Subject ▶ Change on base and addition of O-ring 16 and joint 20

For Models ▶ 9036

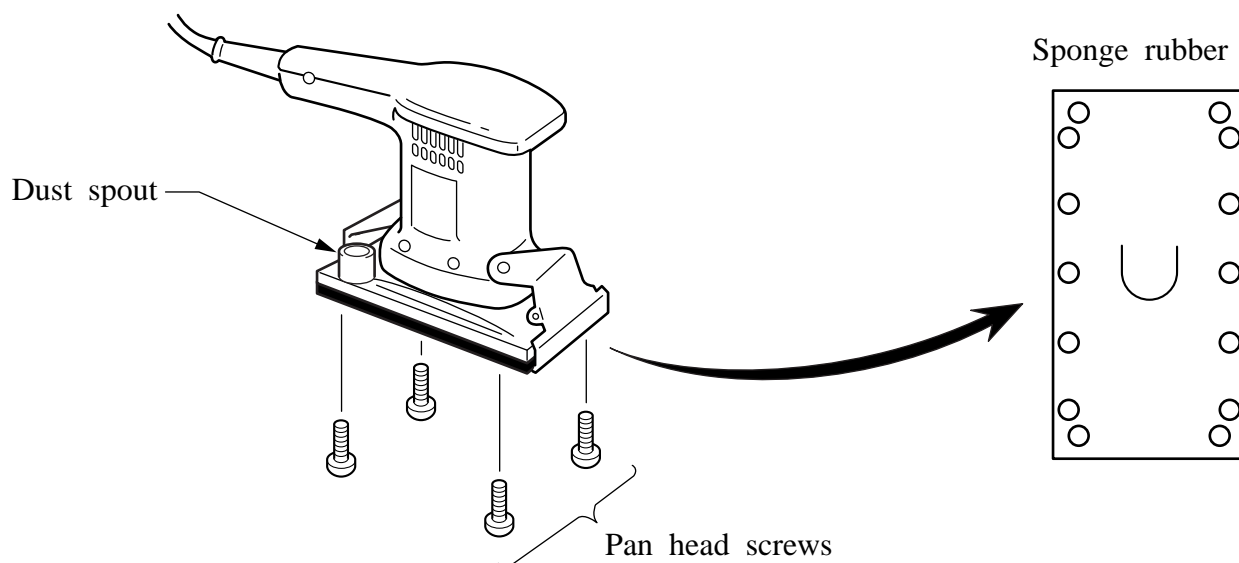
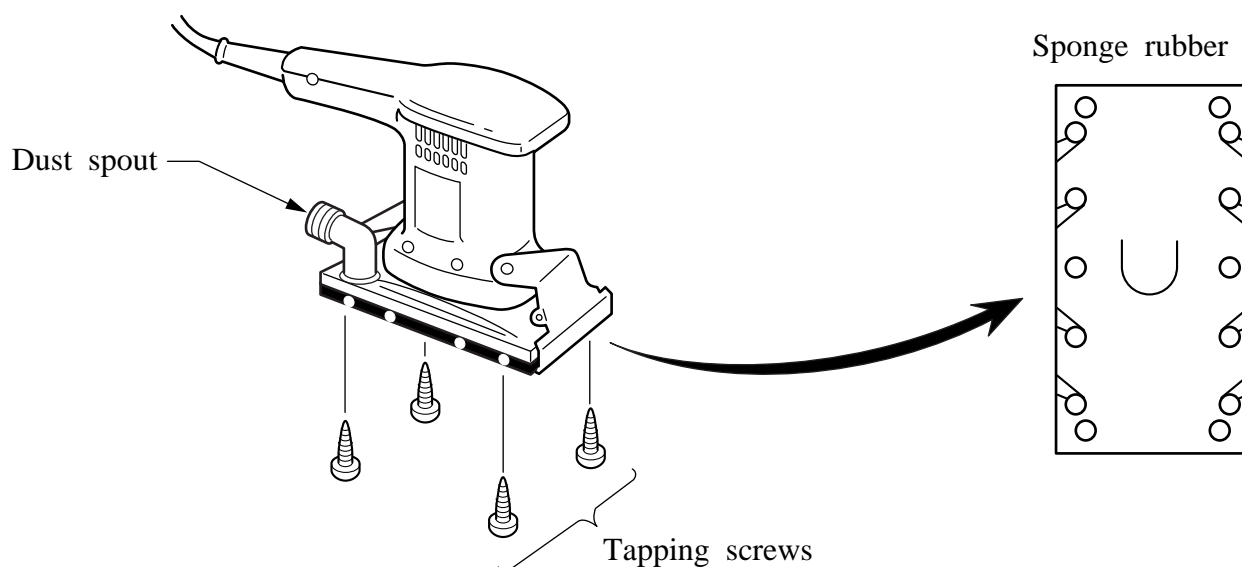
- 1.The dust spout will be changed in shape as shown in the figures below.
- 2.The holes in the sponge rubber will be changed in shape as shown in the figures below.
- 3.The sponge rubber securing screws will be changed from pan head screws M4x10 to tapping screws CT4x12.

► Current

► New

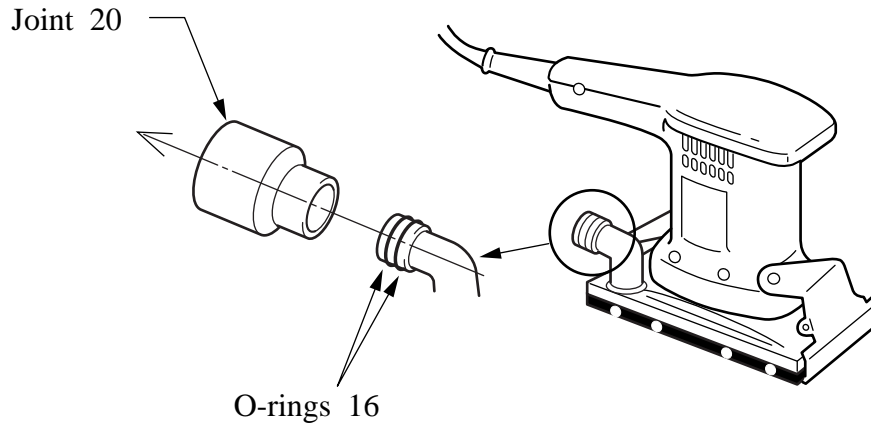
4. For France, Reunion, Algeria, Netherlands, Germany, Spain, Italy, Greece, Austria, Norway, Sweden, Finland and U.K. only.

O-ring 16 and joint 20 will be added as standard equipment. They are for connecting to vacuum cleaners made by European manufacturers such as Bosch, Metabo, etc.

The O-rings 16 are factory-installed on the tool.
